Proposed Mixed Use Development

Quality Audit Report

<b>Client</b>	Bellmount Developments
<b>Project Title</b>	Proposed Mixed Use Development
<b>Project Location</b>	Blackpool, Cork City
<b>Document Title</b>	Quality Audit Report
<b>Document No.</b>	MHL-20068TT-RED-DOC04-QAR
<b>Job No.</b>	20068TT

Figure 5.1 Problem Location Map

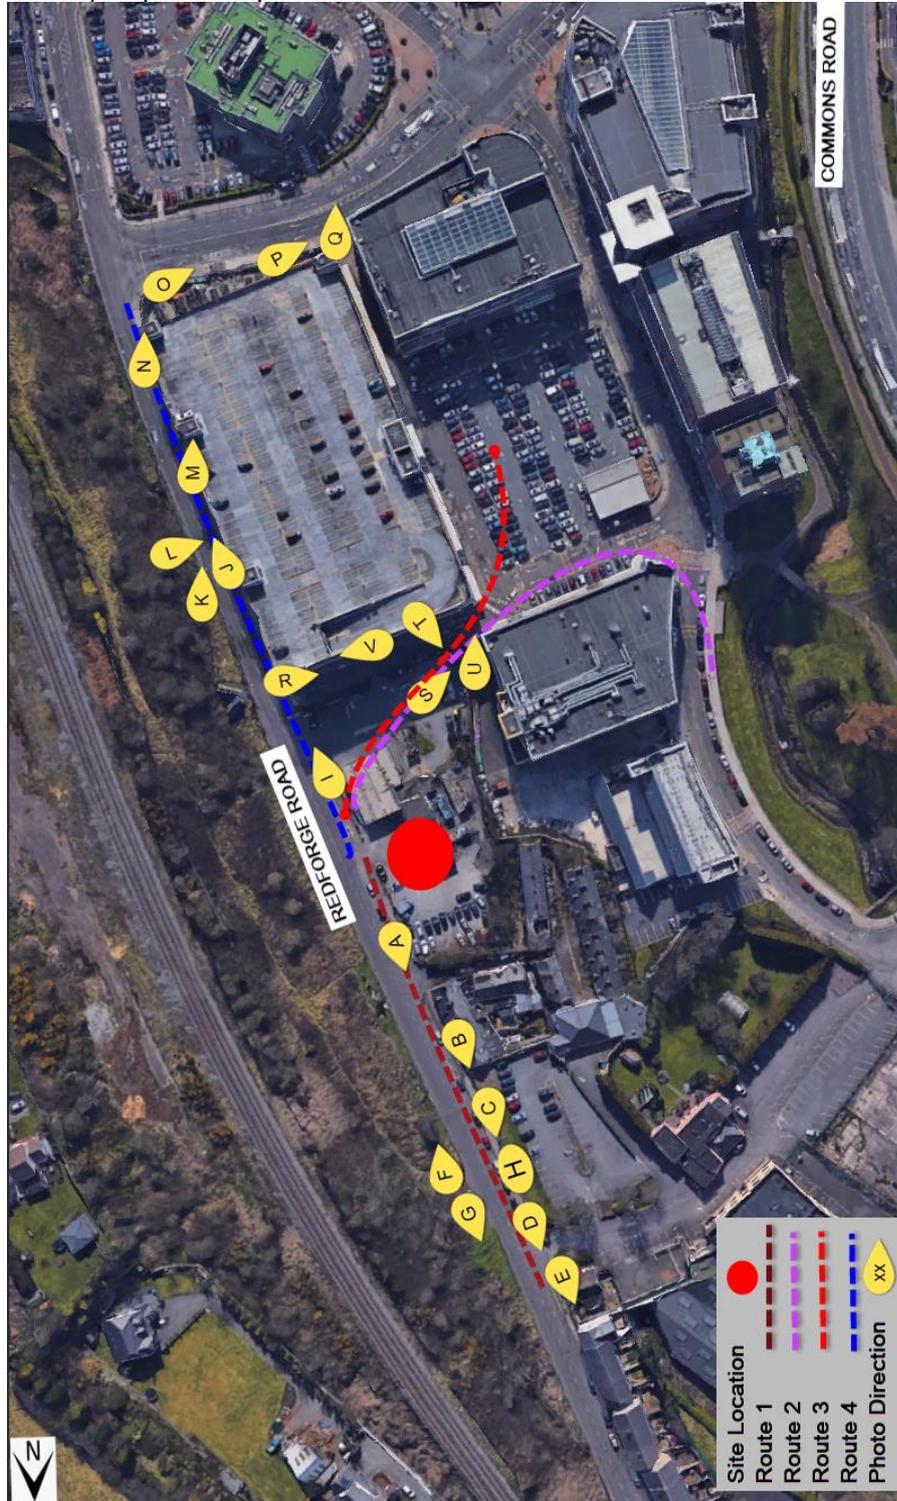
**Issue:** The wide entrance between the applicant's site boundary and nearby cottages, is a discontinuity in the pedestrian facilities at this location. The pedestrian priority is not evident with no appropriate signage present. The footpath is at grade with the nearby carriageway, such that vulnerable road users are at higher risk from collision potentially due to the lack of vehicle separation.

**Issue:** The carriageway between the applicant's site boundary and nearby bus stops along Redforge Road is very wide, leading to ambient traffic speeds higher than what is appropriate for the residential area.

**Issue:** Pedestrian connectivity to the north is provided by public steps. These steps have been installed to account for the inclined gradient of the nearby Redforge Road. This is an issue for mobility impaired users.

**Issue:** Pedestrian connectivity to the far side bus stop is not present. Unregulated pedestrian crossings could lead to collision, injury with passing traffic.

**Issue:** The wide entrance just south of the nearside bus stop is in poor condition and is a discontinuity in the pedestrian facilities at this location. The pedestrian priority is not evident with no appropriate signage present. The footpath is at grade with the nearby carriageway, such that vulnerable road users are at higher risk from collision potentially due to the lack of vehicle separation.

**Issue:** The existing bus stop does not provide a shelter for commuters. The existing footpath is broken, in a state of deterioration.

**Issue:** Forward visibility from the existing bus stop is blocked by nearby hedge overgrowth. The bus shelter offset should be setback to ensure visibility is not impeded.

**Issue:** Forward visibility from the existing bus stop is blocked by nearby hedge overgrowth. The bus shelter offset should be setback to ensure visibility is not impeded.

**Issue:** Forward visibility from the nearside footpath, opposite the far side existing bus stop is blocked by nearby street parking.

**Issue:** Forward visibility from the nearside footpath, opposite the far side existing bus stop is blocked by nearby street parking.

**Issue:** The wide entrance between the applicant's site boundary and nearby retail park, is a discontinuity in the pedestrian facilities at this location. The pedestrian priority is not evident with no appropriate signage present. The footpath is at grade with the nearby carriageway, such that vulnerable road users are at higher risk from collision potentially due to the lack of vehicle separation.

**Issue:** The existing pedestrian footpath facilities along the Retail Park Laneway are poor, with a very narrow footpath available on one side of the lane. The existing laneway is a single carriageway with entry/exit traffic from the nearby retail area. Vulnerable road users are at higher risk from collision potentially due to the lack of vehicle separation.

**Issue:** Narrow footpaths on the Retail Park laneway may present difficulties for vulnerable road users.

**Issue:** Pedestrian footpath widths to the retail park from the applicant’s back site access are restricted. Unregulated pedestrian crossings could lead to collision, injury with passing traffic.

**Issue:** Narrow footpaths on the Retail Park laneway may present difficulties for vulnerable road users.

**Issue:** The existing wide carriageway of Redforge Road is a vehicle dominated design, with the nearby multi storey carpark imposing on the roadway. This section of roadway is a pleasant streetscape, with vulnerable road users exposed to passing traffic.

**Issue:** The rear of the retail park has numerous access ways along this section of the desire line. These should be accommodated in any street improvement works to ensure pedestrian safety as well as providing access for maintenance of the retail park.

**Issue:** The wide access entrances to the back of nearby retail park are hazards, presenting a discontinuity in the pedestrian facilities at these locations. The pedestrian priority is not evident with no appropriate signage present. The footpath is at grade with the nearby carriageway, such that vulnerable road users are at higher risk from collision potentially due to the lack of vehicle separation.

**Issue:** The pedestrian protection at this crossing location is poor. At the crossing, the existing traffic junction's poles narrow the available footpath space available for passing footpath and pedestrian waiting to cross the road at this location.

**Issue:** The existing footpath has deteriorated in certain locations, which the existing bus stop shelter confining the available footpath widths for passing pedestrians. These confined dimensions can lead to mobility issues for wheelchair access and lead to pedestrian / vulnerable road users entering into the road carriageway at this location, leading to potential collisions.

**Issue:** The existing footpath at the drop kerb location as shown has no pedestrian protection/ vehicle restraint to protect vulnerable road users at this location. Protection measures in the form of bollards, planters, etc should be provided.

**Issue:** The existing uncontrolled crossing location is poorly defined, with sub optimal pedestrian protection/ vehicle restraint provided.

**Recommendation:** Provide appropriate signage, uncontrolled tactile paving/dropped kerbing and pedestrian crossing facilities at this location to ensure continuity of the footpath network.

**Recommendation:** Provide appropriate signage, raised tables, narrowed carriageway in line with DMURs requirements.

**Recommendation:** Appropriate ramp facilities and tactile paving (top and bottom of steps) to be employed to allow for disabled connectivity access to the bus stops located north of this location. If these ramp facilities cannot be delivered at this location, appropriate tactile paving and accessible hand rail should be provided.

**Recommendation:** Appropriate pedestrian crossing facilities to be provided at this location, linking the far side bus stop to the existing public footpath network.

**Recommendation:** Provide appropriate signage, uncontrolled tactile paving/dropped kerbing and pedestrian crossing facilities at this location to ensure continuity of the footpath network. Review the intended improvements at the junction related to the adjoining development which may address this issue.

**Recommendation:** The possibility of providing appropriate bus stop shelter to be evaluated at this location and provided if feasible. The existing footpath should be reinstated to avoid/ minimise potential trip hazards to users. Review the intended improvements at the junction related to the adjoining development which may address this issue.

**Recommendation:** Ensure appropriate forward visibility is provided to waiting commuters and pedestrians crossing the road at this location. Ensure kassel kerbing is employed at the new bus stop kerb edge.

**Recommendation:** Ensure appropriate forward visibility is provided to waiting commuters and pedestrians crossing the road at this location. Ensure kassel kerbing is employed at the new bus stop kerb edge.

**Recommendation:** Ensure appropriate forward visibility is provided to waiting commuters and pedestrians crossing the road at this location. Ensure appropriate crossing facilities in the form of build outs and controlled crossing facilities are provided.

**Recommendation:** Ensure appropriate forward visibility is provided to waiting commuters and pedestrians crossing the road at this location. Ensure appropriate crossing facilities in the form of build outs and controlled crossing facilities are provided.

**Recommendation:** Provide appropriate signage, uncontrolled tactile paving/dropped kerbing and pedestrian crossing facilities at this location to ensure continuity of the footpath network.

**Recommendation:** Provide appropriate footpath widths to facilitate the passing footfall along this section of roadway, insuring nearby loading areas are prevented from blocking pedestrian along this desire line, which could lead to pedestrians being forced to enter the vehicle trafficked area.

**Recommendation:** The footpath on the applicant side should be designed to an appropriate standard to safely accommodate pedestrians along this route.

**Recommendation:** This is outside the control of the applicant and that the retail park should improve connectivity at the location.

**Recommendation:** This is outside the control of the applicant and that the retail park should improve connectivity at the location. The footpath on the applicant side should be designed to an appropriate standard to safely accommodate pedestrians along this route. Ensure appropriate footpaths width are developed to provide adequate mobility and protection for vulnerable road users to the nearby retail park.

**Recommendation:** Provide streetscape improvement measures compliant to DMURs standards to ensure this link is a pedestrian friendly one, enhancing the desire line for existing and future residents/ pedestrian of the area.

**Recommendation:** Provide streetscape improvement measures compliant to DMURs standards to ensure this link is a pedestrian friendly one, ensuring the Blackpool Retail Park access is maintained.

**Recommendation:** Provide appropriate signage, uncontrolled tactile paving/dropped kerbing and pedestrian crossing facilities at this location to ensure continuity of the footpath network.

**Recommendation:** The poor footpath surface should be replaced at this location, with appropriate signalised red tactile paving installed. The exiting poles should be repositioned to provide appropriate pedestrian footpath widths.

**Recommendation:** Poor footpath surface should be replaced. The bus shelter positioning should reflect the passing of pedestrian traffic / wheelchair and child buggy footfall.

**Recommendation:** Provide appropriate pedestrian protection at this location.

**Recommendation:** Provide appropriate pedestrian crossing facilities at this this location.
